BUILDING INSPECTION PERMIT

Permit Number: 030326

This is to certify that Stasium Mark V Living Trust / Sean O Reilly
has permission to Add a 2-story 18'6" +/- x 12' addition
AT 17 Dennett St 285 A004001

Stasium Addition
Plans
O'Reilly Construction
671-5965
285-A-004

1ST FLOOR LAYOUT
SCALE 1/4" = 1'-0"

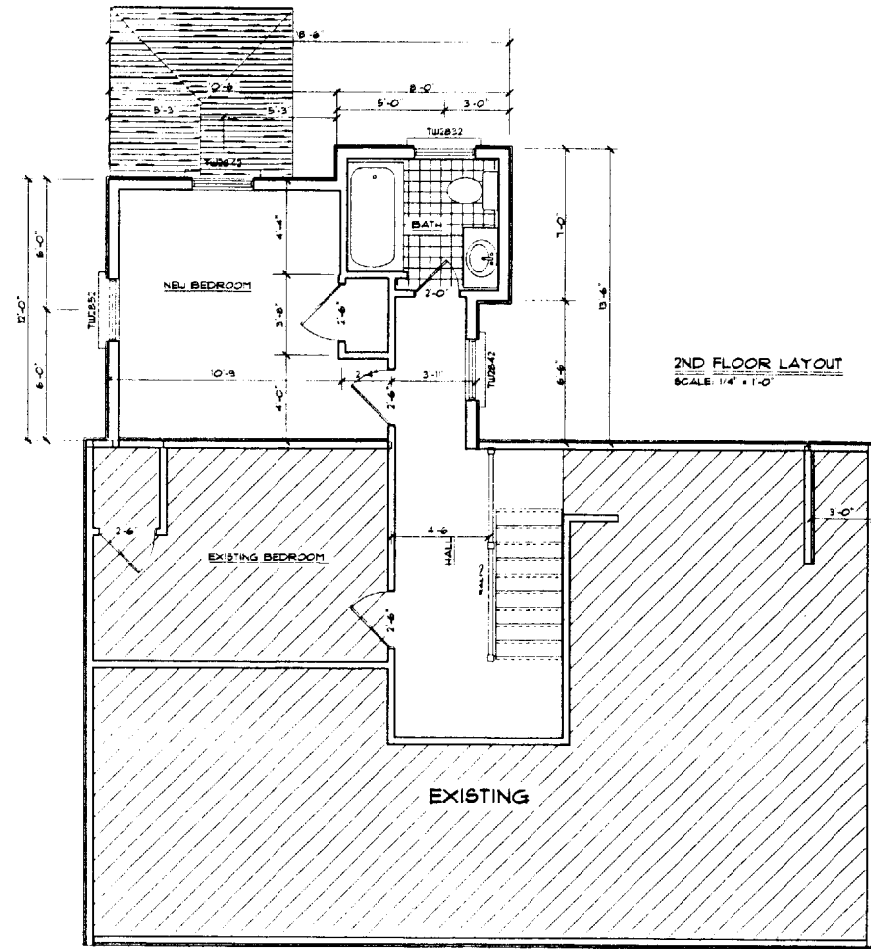
Need following -

- ① 13' Header in kitchen
- ② Beams in eating area & 2nd flr bath.
- ③ Headers over double window in eating area.
- ④ Stairs.

The stairs at the deleted deck are going to go at the kitchen door
They will meet code.

The beam sizes are as follows

5 1/2" x 9 1/2" x 12' at kitchen

3 1/2" x 9 1/2" x 7' and 3 1/2" x 9 1/2" x 5'5" with a simpson HU410 hanger at breakfast nook.

*Treads will be 11"
Risers - 7"
Guards 42" high
w/ 34" handrail.*
